Kensington Aldridge Academy, London W10

Fire Safety Review

June 2018

Figure 1 – Section through main external wall type

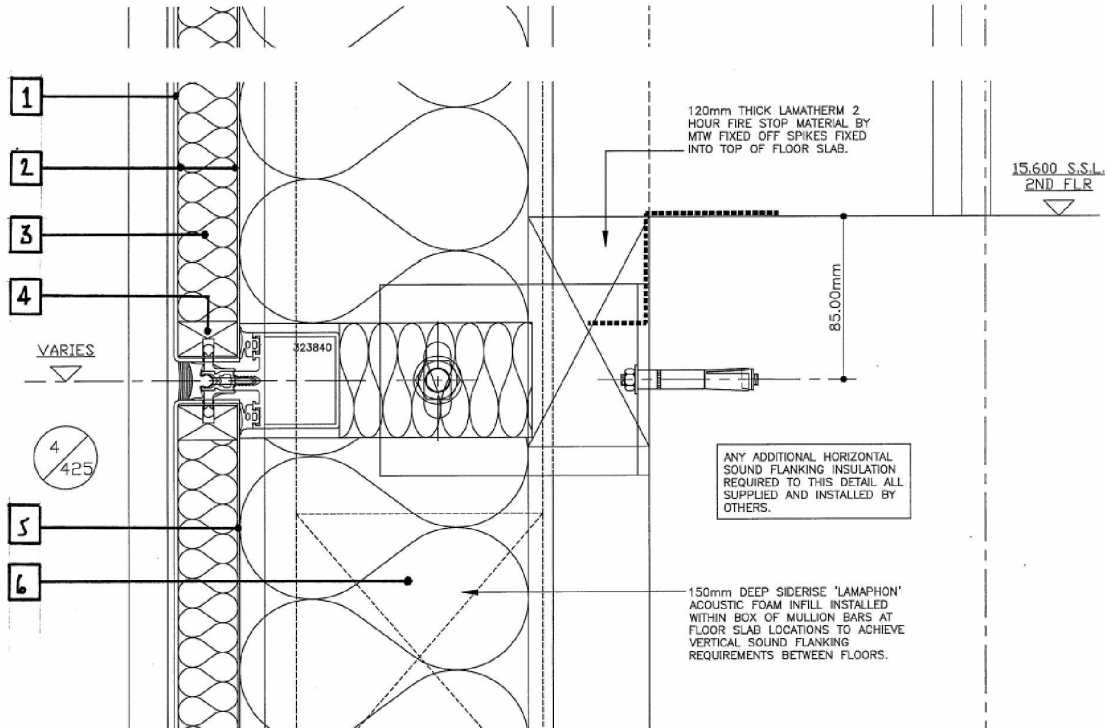
3.0.1 The building structure comprises a reinforced concrete frame and floors. The external walls are lined internally with plasterboard sheets and externally with a proprietary ACM panel as shown in Figure 1 below. The rest of the external wall specification is confirmed below.

3.0.2 The perimeter of the ACM panels are machine with 80 mm long slots to allow the panels to be fixed using a Schuco retaining toggle. The joints between the panels are sealed with a resilient flexible sealant and cavity barriers are closed state (i.e. no ventilation openings) therefore it as an unventilated rainscreen cladding system.

Figure 2 – Lower ground floor level

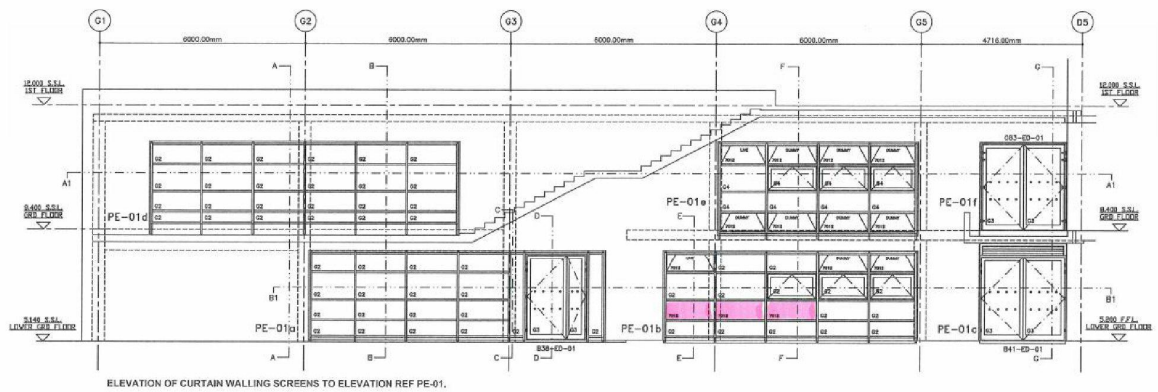
3.0.3 As an alternative to the specification shown above, Kingspan K15 insulation (phenolic foam with a Class C-s1, d0 reaction to fire) is used instead of Rockwool for acoustic reasons. This alternative specification relates to three panels in one room at lower ground floor level (see Figure 2) and seven classrooms at ground floor level (see Figures 3 and 4) as highlighted in pink.
